Sansui SERVICE BULLETIN

June 1, 1970
Ref. CE-013

Subject: MODIFICATION OF THE POWER CIRCUIT
Model: 2000A

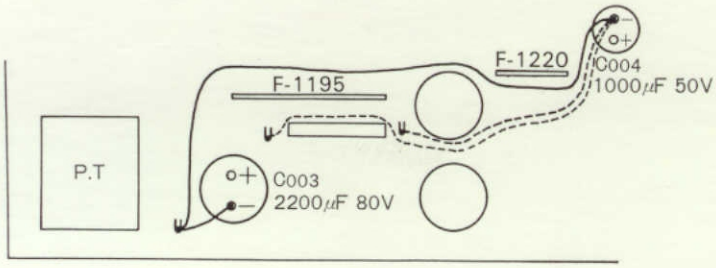
1. If noise (input shorted) is noticeable in the power amplifier sections, change the connecting wire and grounding point in the power circuit.
   See Fig. below:

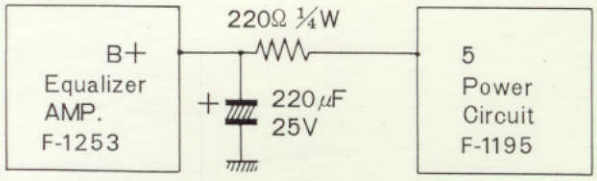
2. If Hum level is noticeable on PHONO 1 or 2 of the SELECTOR, insert the ripple filter between the equalizer amplifier "F-1253 (+B) and power circuit" F-1195 (5).
   See Fig. below:

STOCK NO.	DISCRIPTION
0101221	220Ω ¼W
0513221	220μF 25V
